TO: Development Review Board
FROM: Scott Gustin *SG*
DATE: September 20, 2011
RE: 12-0253CA/CU; 259 Appletree Point Road

Request: Increase height of concrete seawall and reinforce with rip rap

259 Appletree Point Road
Seawall Repair and Buttress
August 18, 2011

**259 APPLETREE POINT ROAD
SEAWALL REPAIR - BUTTRESS**

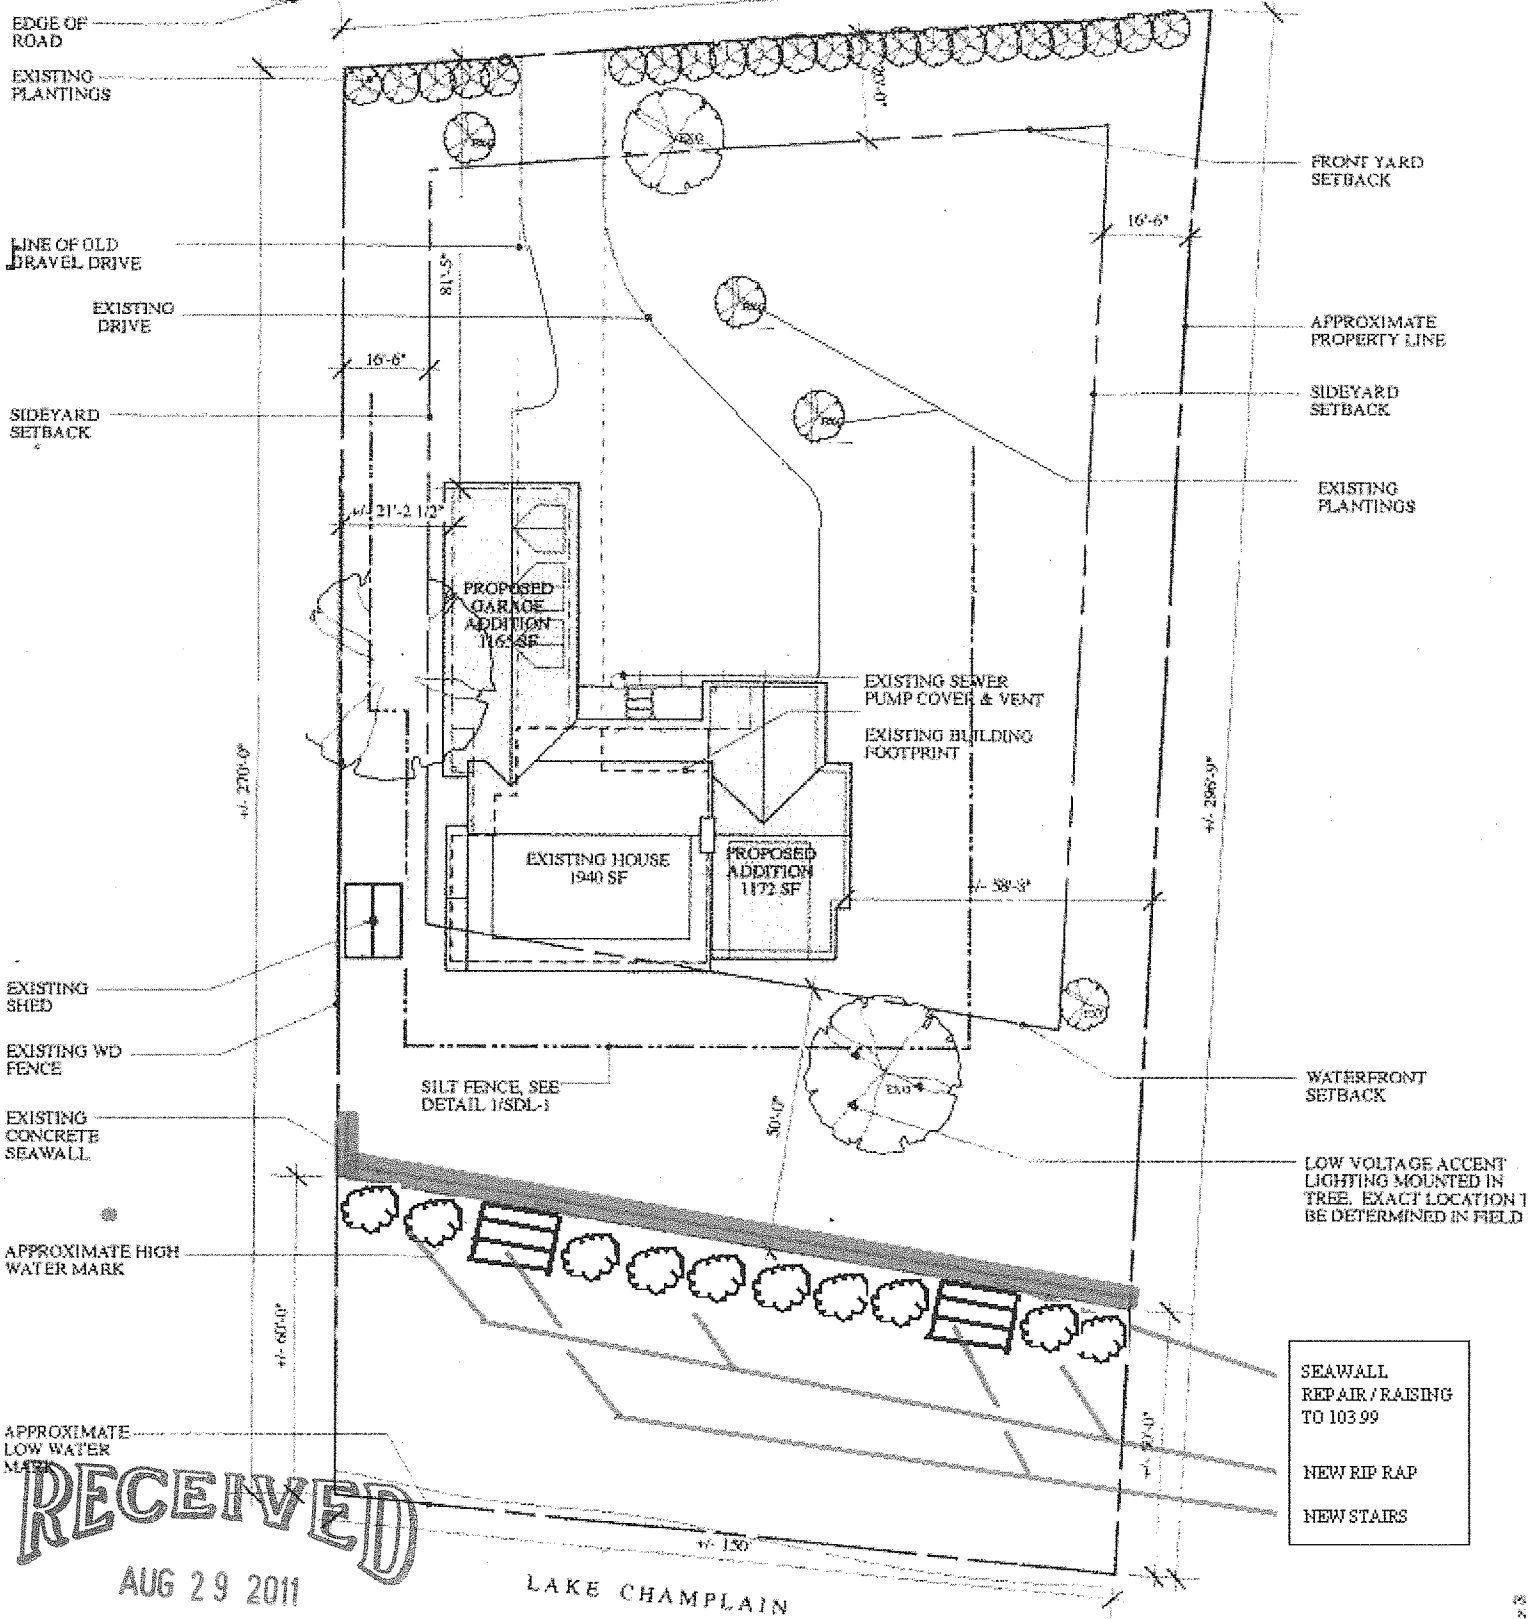
The proposed rip rap and stairs will increase lot coverage. No lot coverage figure has been provided and one is needed; however, the parcel appears to remain below the 35% coverage maximum. The rip rap is located within the 75' lakeshore setback; however, it may encroach into this setback per Sec. 5.2.5, *Setbacks*, (b) *Exceptions to Yard Setback Requirements*. The modified seawall and associated rip rap are well under the maximum allowable height of 35'. **(Affirmative finding as conditioned)**

No new landscaping is proposed beyond the restoration of lawn between the house and the seawall. Vegetative screening of concrete seawalls has been required in the past. As the proposed rip rap will line the front of the seawall and will consist of large stone blocks similar in appearance to the naturally occurring ledge along parts of the Burlington shoreline, no screening is required. Vegetation will establish itself naturally over time amongst the stone. **(Affirmative finding)**

1. **Prior to release of the zoning permit**, revised plans depicting proposed lot coverage shall be submitted, subject to staff review and approval.
2. **Prior to release of the zoning permit**, written approval of the small project erosion control plan shall be obtained from the Stormwater Administrator.
3. This approval incorporates timely comments and stipulations issued by the State National Floodplain Insurance Program Coordinator at VT DEC as related to this project.
